City Of Palo Alto ADU Ordinance, First Reading, Meeting Date 10/5/2020 Agenda Item #8

15 Suggestions for Consideration:

- c. Consider adopting language similar to that used in Santa Cruz:

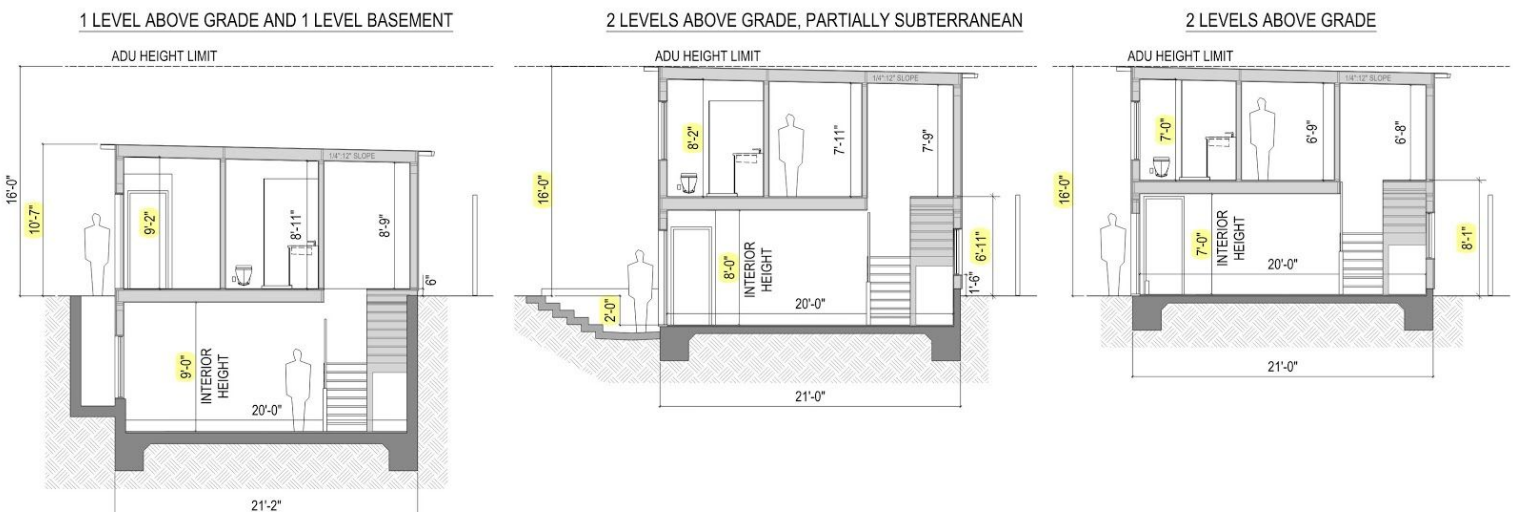
- i. ADUs higher than one story may be up to 22' tall at the peak, measured from average grade, and any portion of the structure that exceeds 16' in height must be set back a minimum of 5' from the side yard property line and 10' from the rear yard property line.
- ii. Exception: An ADU that faces an alley or street can be up to 22' tall and any portion of the structure that exceeds 16' in height must be set back 5' from the side and rear property lines.
- iii. Detached New Construction ADUs higher than one story shall limit the major access stairs, decks, entry doors, and windows to the interior of the lot or an alley if applicable. Windows that impact the privacy of the neighboring side or rear yards should be minimized or otherwise restricted as in (b.) above

5. Minimal increase to non-conforming structures

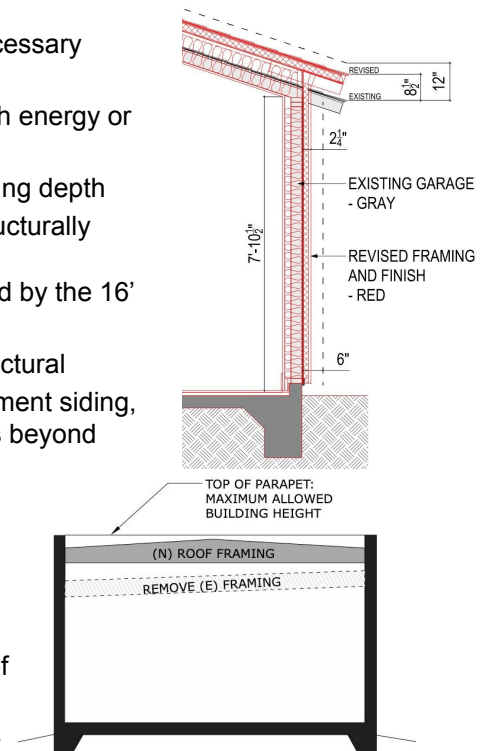
- a. Create an allowance to avoid complete demolition or unnecessary complexity due to energy or structural upgrades
 - i. Clarify that it can only be accessed for compliance with energy or structural obligations

- 1. Grant an additional 12" of height – increase framing depth above top plate rather than hanging, which is structurally complex and reduces ceiling heights.

- 2. Note that the structure height will still be restricted by the 16' height limit.
 - 3. Grant an additional 6" in plan on any side for structural seismic sheathing, exterior insulation, or replacement siding, so long as no portion of the structure encroaches beyond the property line.

- ii. Add a clarification regarding structures with existing parapets. A non-conforming portion of the structure may be modified up to the height of the existing parapet. This can be done without creating an increased impact to neighbors. Previous interpretation of 'shrink-wrap' rules should not apply to recessed roof areas below the top of the parapet. This flexibility will allow the interior to be a reasonable residential height.

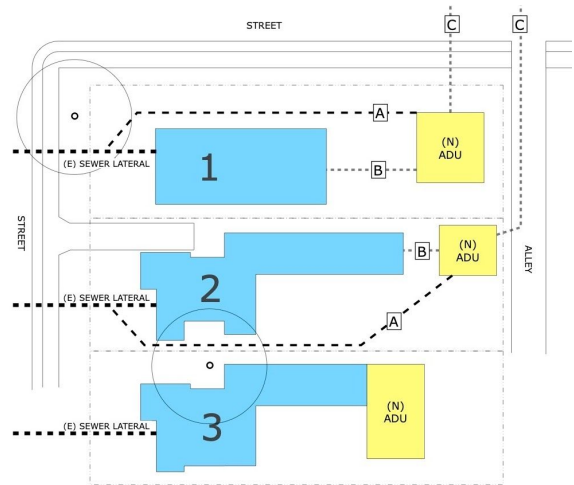
- c. Routing of utilities at the discretion of property owner (rear alley or another alternate to avoid disruption to landscape or trees)
 - i. This graphic compares three lots with an alley behind. Parcel 3 has an attached ADU and the sewer may connect to the main house line. There is no impact to the site. Parcels 1 and 2 have detached ADUs and are currently required to run their sewer line shown as 'A', around the main house, and out to the street at the front yard. This is highly problematic, especially if there are protected trees on site. A reasonable option would be to allow the sewer line placement shown by the 'B' or 'C' routing.
